Hydromodification Software Review

County of San Diego

HSPF Implementation

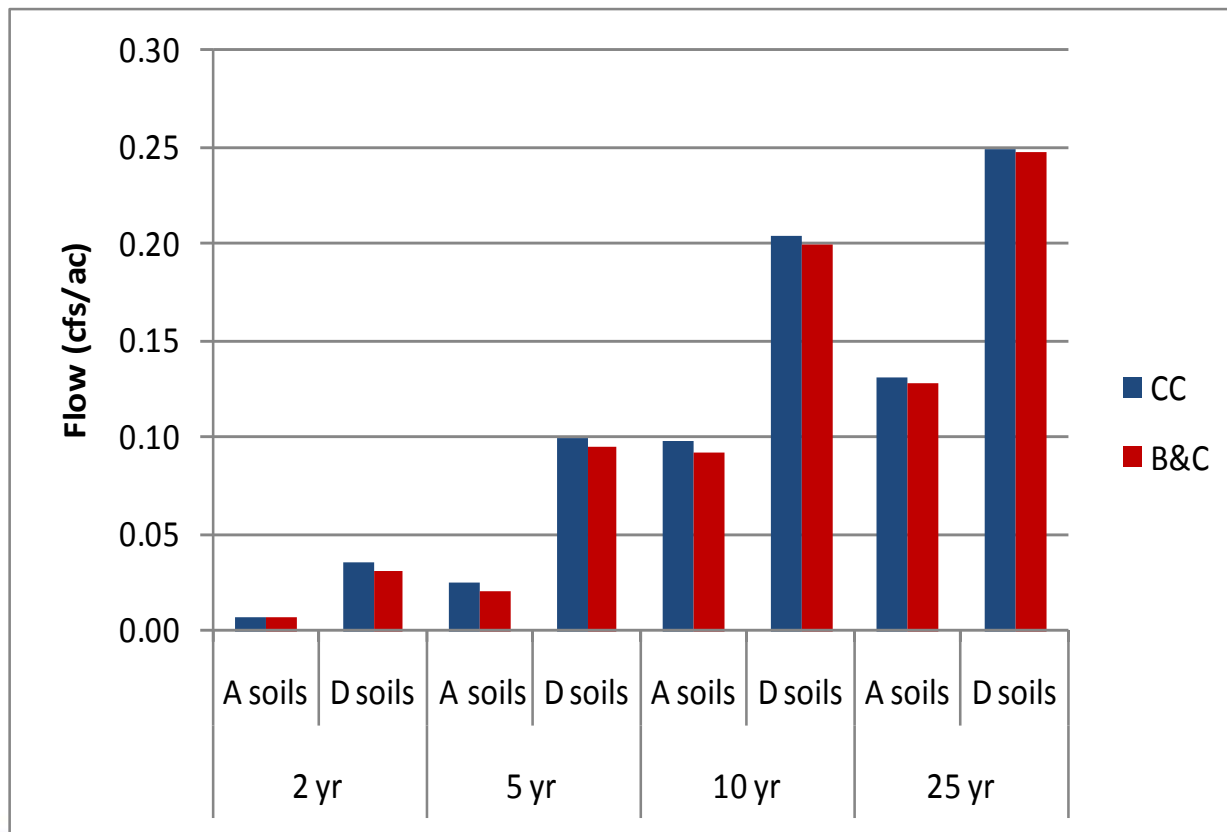
- Models use same weather data
- SDHM adds irrigation on urban pervious land, B&C does not
- This makes a big difference in total flows
 - Reason for B&C omission not fully clear
 - SDHM assumptions are not documented
- Does not directly impact sizing factors because these assume runoff only from impervious land
- Would impact pond sizing

Post-development Pervious Flow

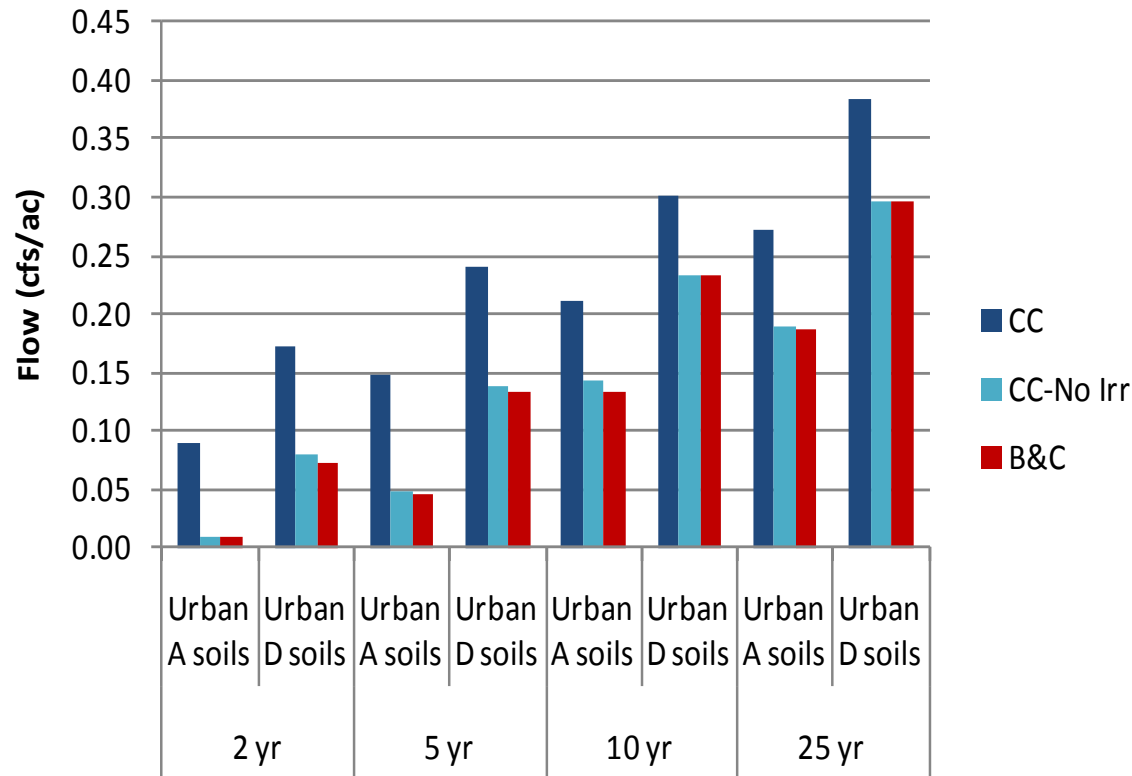
- Irrigation makes a big difference

Implications for Facility Sizing

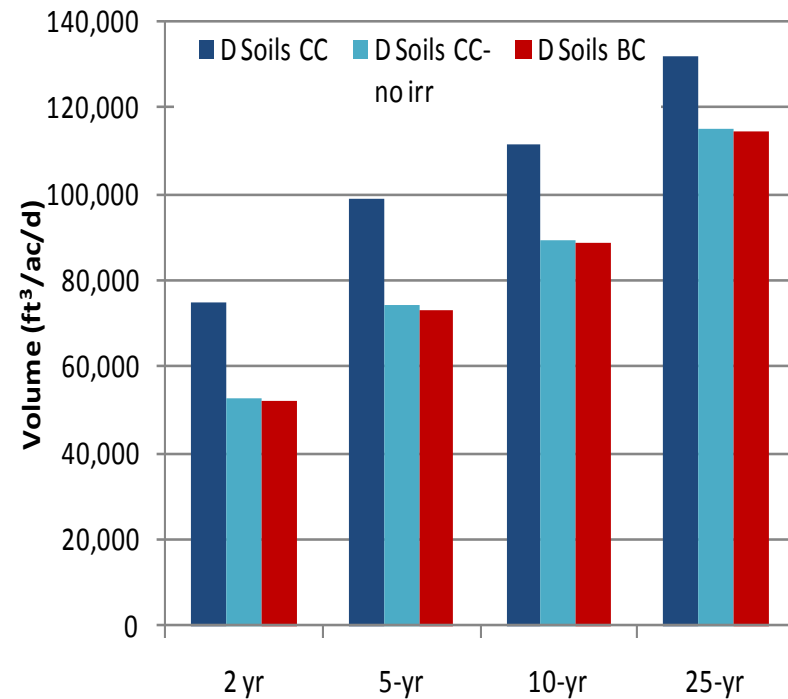
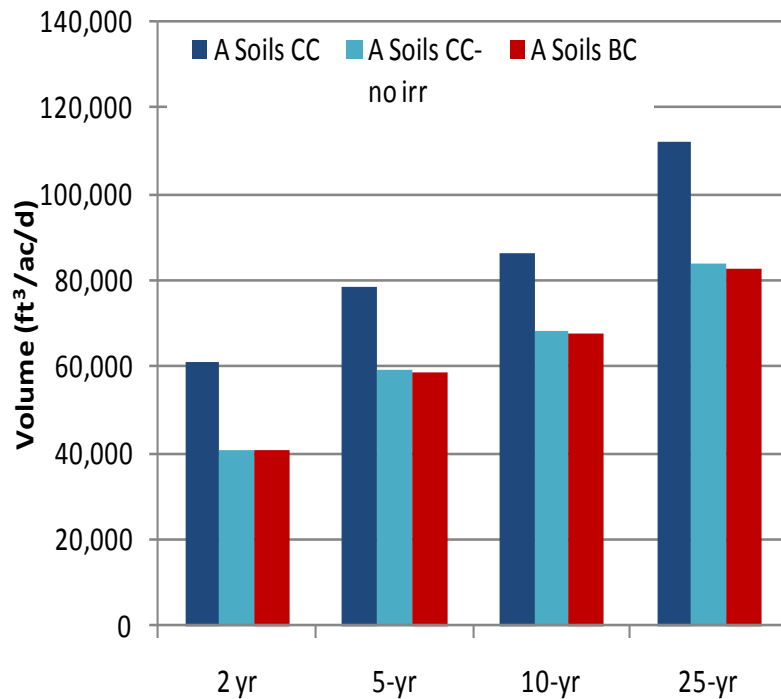
- Look at total flow from a medium density residential parcel at 30 percent impervious – not just the impervious flows
- Total volume to control is difference between post-development and pre-project flows
- SDHM has slightly higher flows both pre-project and post-development, so differences tend to cancel out

B&C Approach to Pervious Urban Land

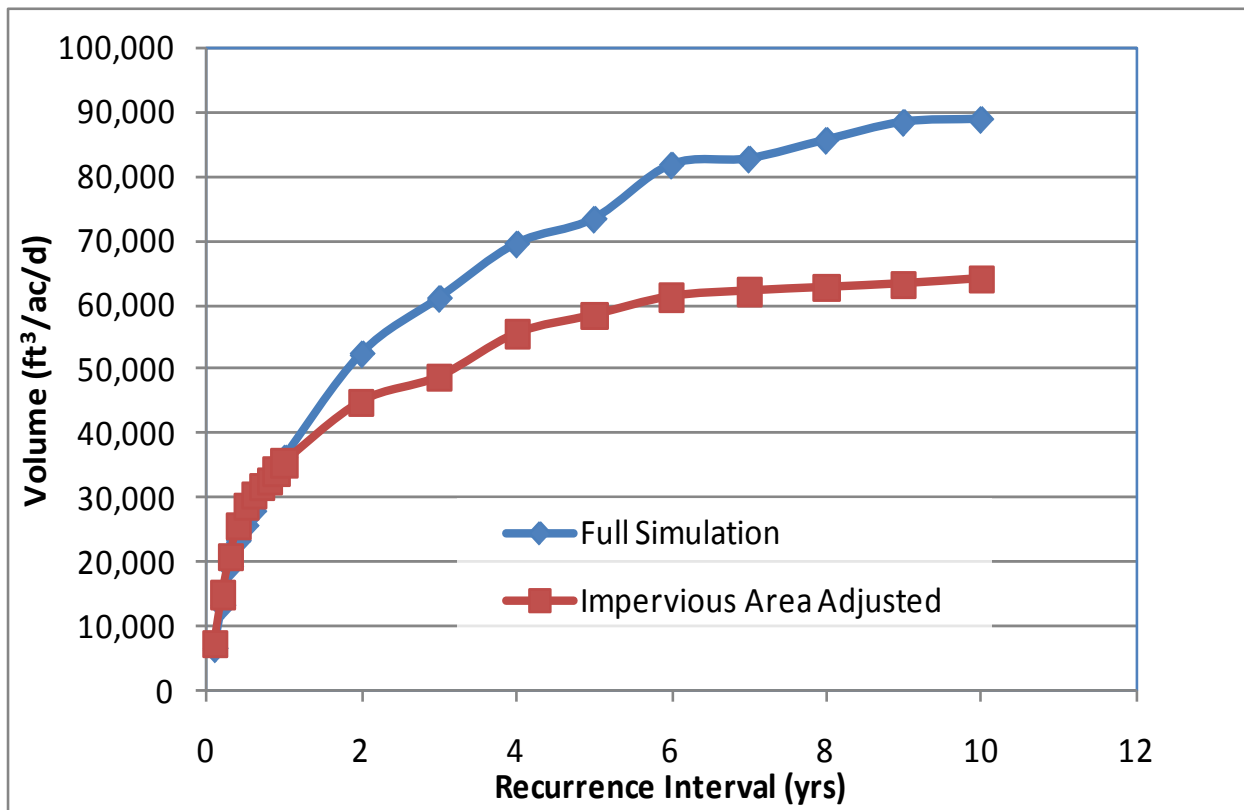
- If pervious land is in drainage area to BMP, it's treated as producing runoff at rate of 10% of the impervious land
- This works, to a degree, but will tend to underestimate total flows during large events on soils with poor infiltration rates
- Are the SUSMP expectations that pervious areas will be improved to be "self retaining" realistic?

Differences in BMP Simulation

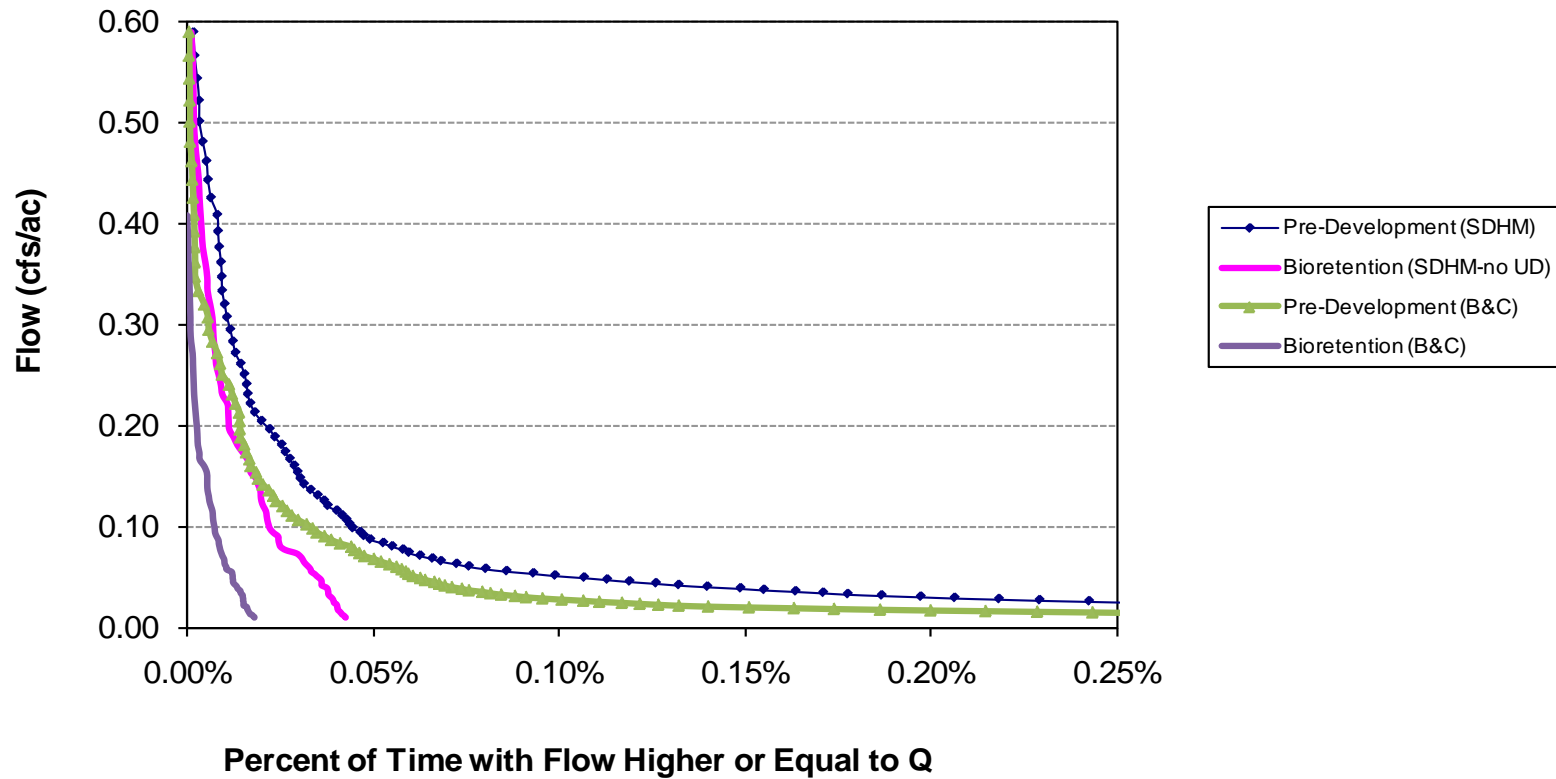
- Slight differences in hydraulics
- SDHM uses Special Actions to cap percolation rate when pore space is filled
- Evapotranspiration from LID:
 - B&C applies PET x 0.78 to surface layer only
 - SDHM applies PET x 0.5 to surface soils; x 0.7 to the subsurface layer
- SDHM contains multiple user options, does not force user to follow prescribed designs

Ability to Simulate Peak Flows

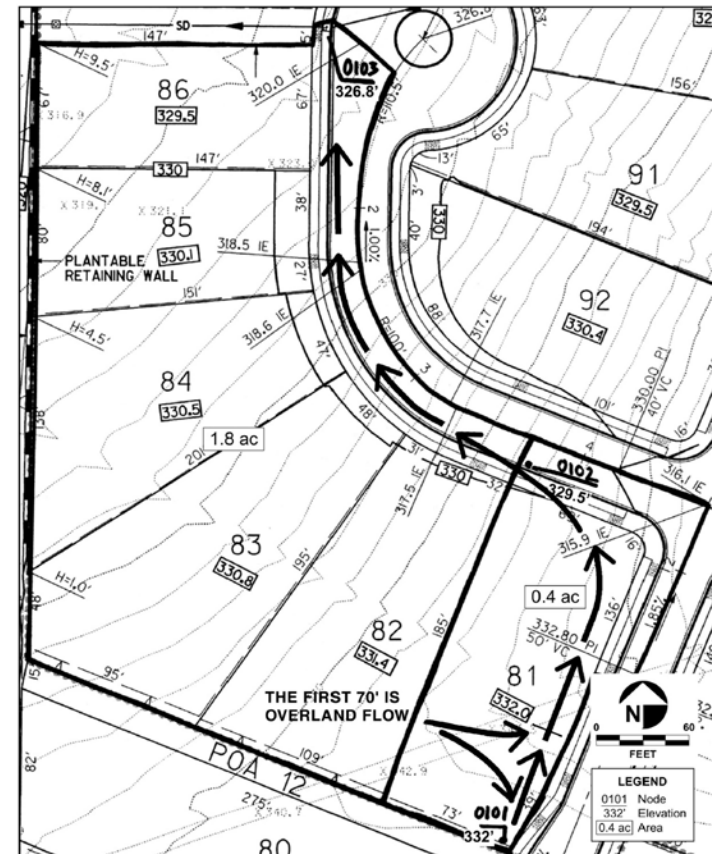
- Brown & Caldwell and SDHM models both run at an hourly time step
- Typical time of concentration for runoff at the development scale is on order of 10-15 minutes
- HSPF simulations at an hourly time step CANNOT estimate instantaneous peak discharges
- Can compare peak flows at hourly duration

1-hr Duration Peak Flows

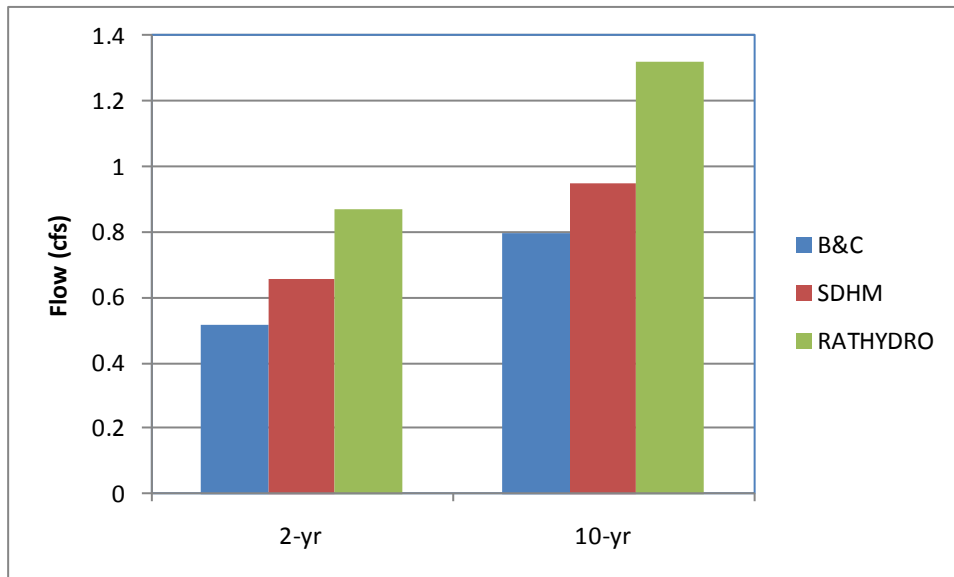
- SDHM > B&C due to urban irrigation (impervious runoff is identical)
- Both methods underestimate Rational Method hydrograph
- Difference is mostly due to rainfall series: 1959-2004 stats < isopluvial amounts of same duration
